**PROJECT: Multi-Sport Venue in Eastern New Orleans and Lower Ninth Ward
4290 Almonaster Avenue,
New Orleans, LA 70126**

ADDENDUM NO. 6

July 2, 2025

This Addendum forms a part of the Contract Documents and modifies the Project Manual – Volume 1 and 2, and Drawings dated January 30, 2025. Clarifications and revisions noted below are in response to the project solicitation posted on May 29, 2025.

1 SOUTH EAST LOCKER ROOM FOUNDATION PLAN
S102 1/8" = 1'-0"

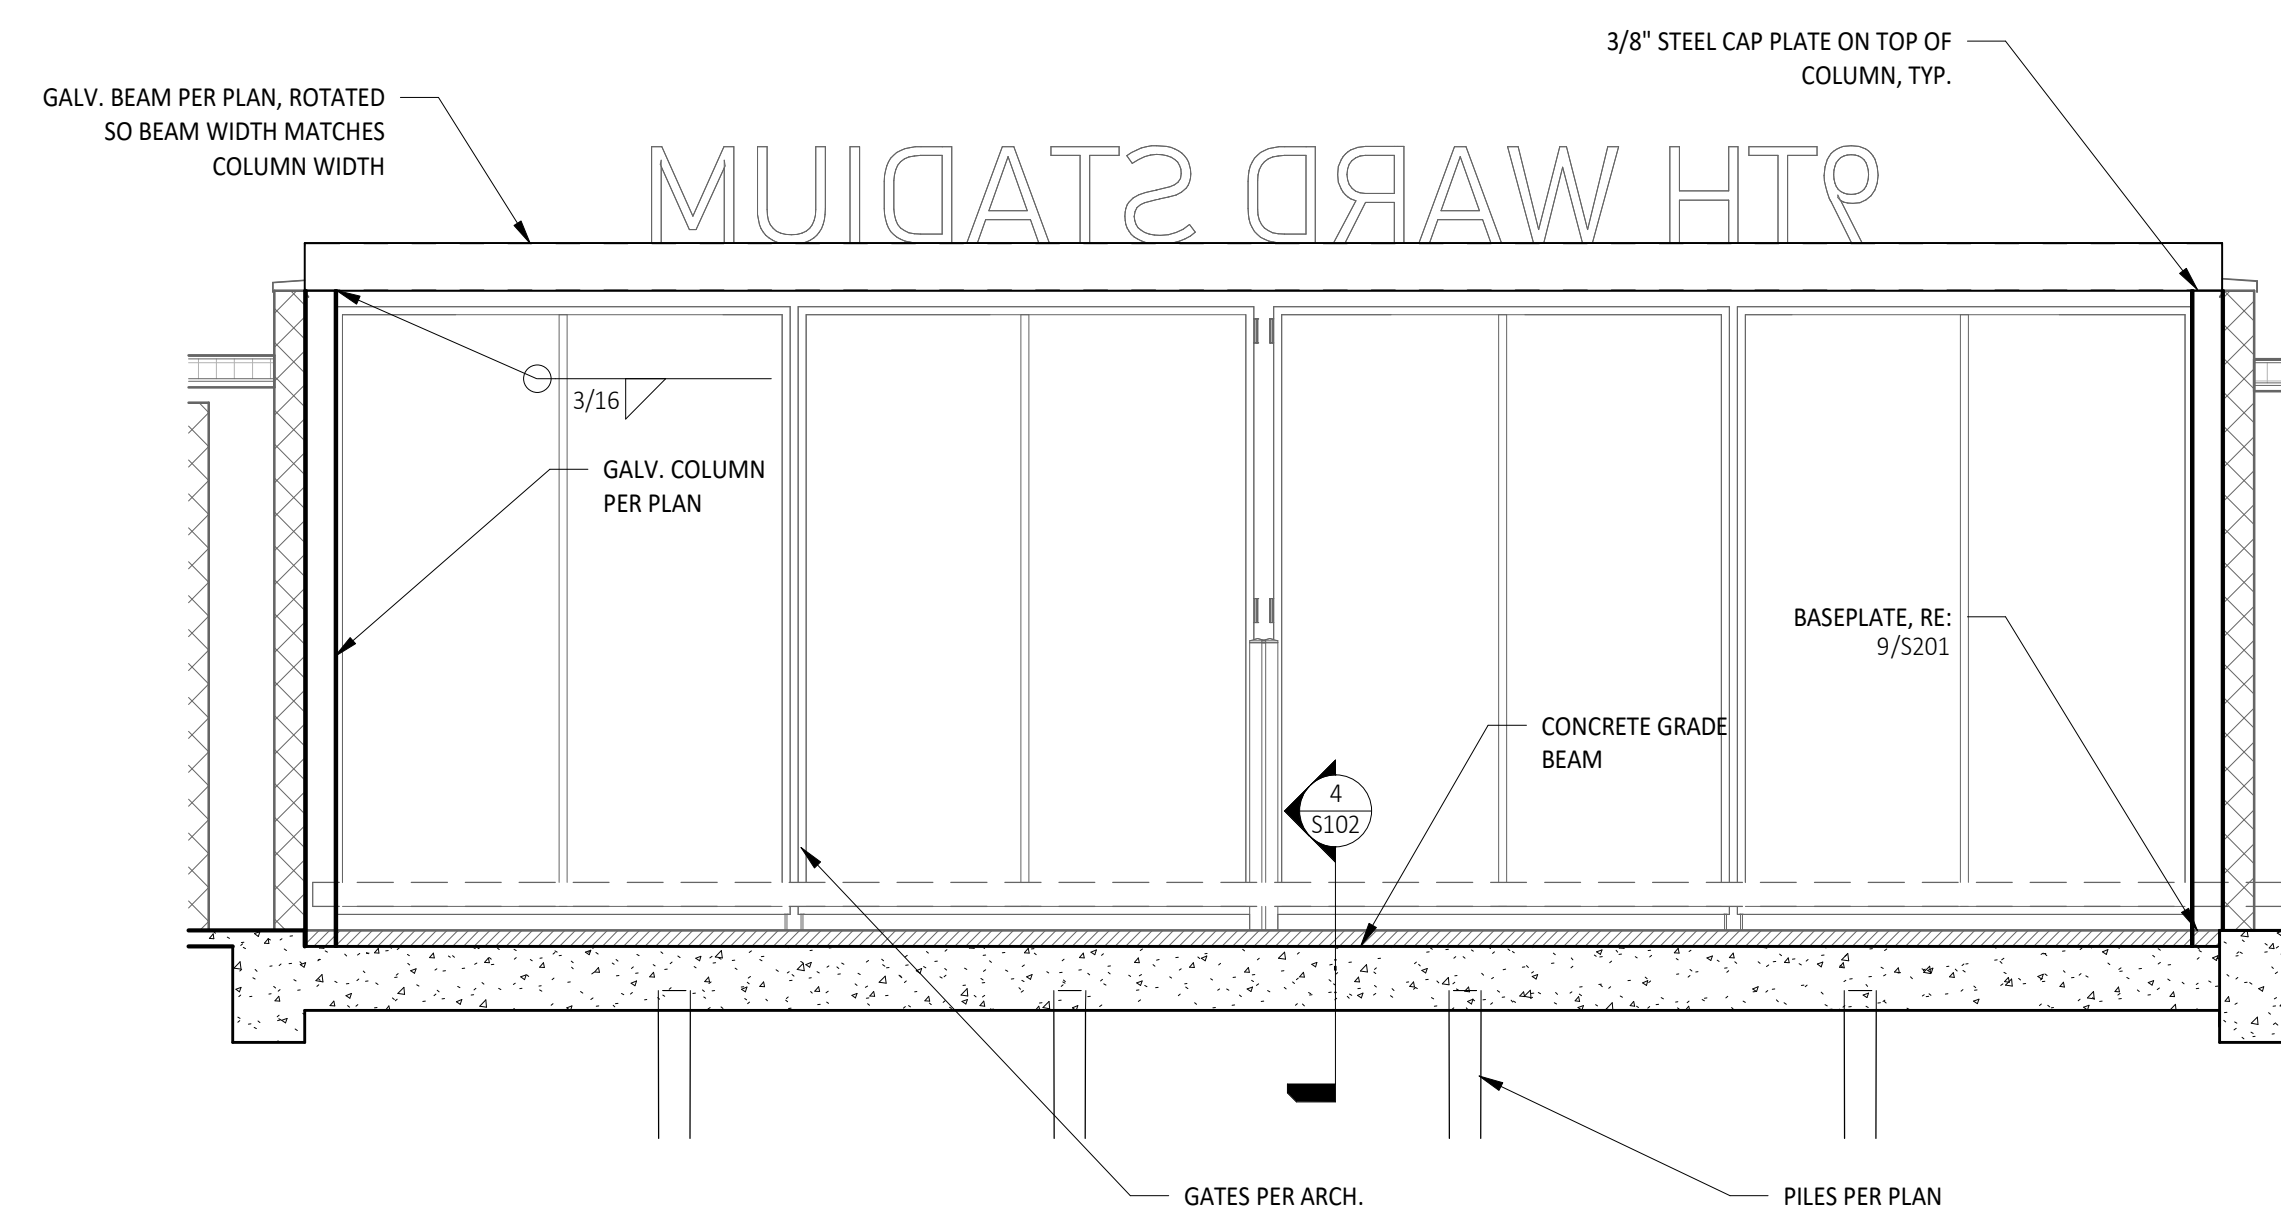
- The drawings show the design intent for the Away Bleachers with gravel between grade beams.
13. Can you please identify the building foundations shown on sheets S100, S101, S102, and S103 for clarity. They are all labeled as "Building Foundation Plan" with no references to the site plan.

- Labels have been updated in attached revised structural sheets.
14. There are two call outs for prefab posts for the gate, but it is not clear what it is pointing to.

3 SECTION
S105 S200 1" = 1'-0"

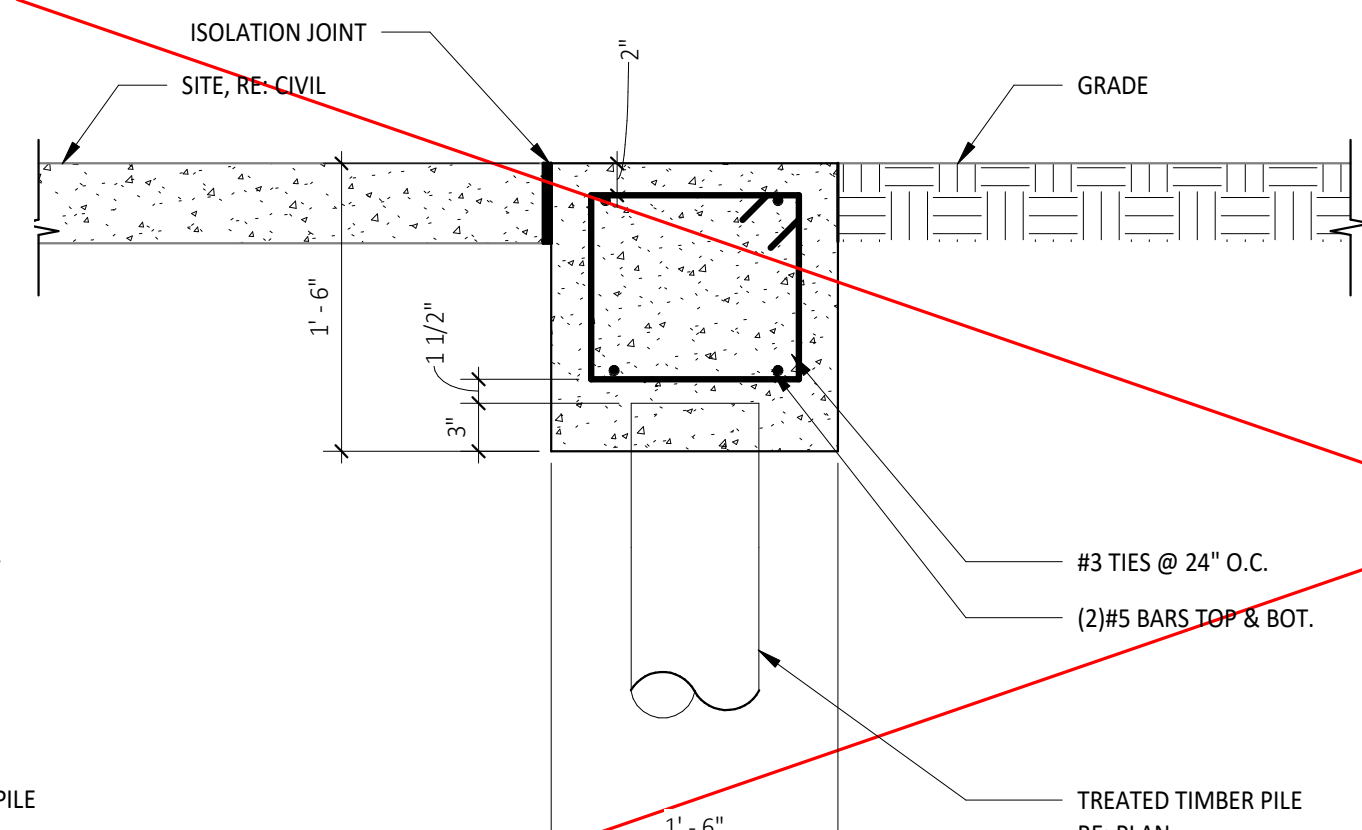
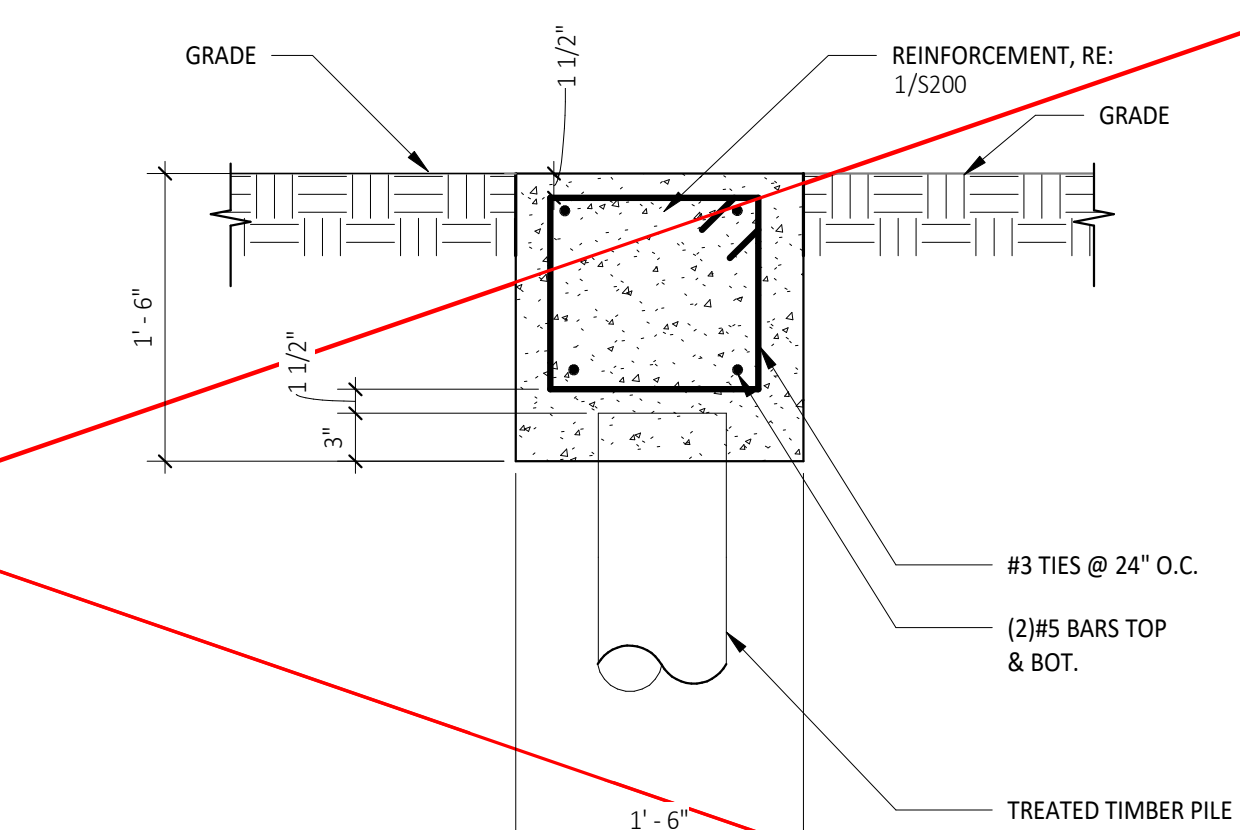
12. The Away Bleachers on Sheet S105 reference sections 3 and 4 on sheet S200 which do not show a continuous and monolithic slab on top of the grade beams. Section 4 doesn't show any concrete on either side of the interior grade beams. Can you please clarify the intent for the slab for these bleachers?
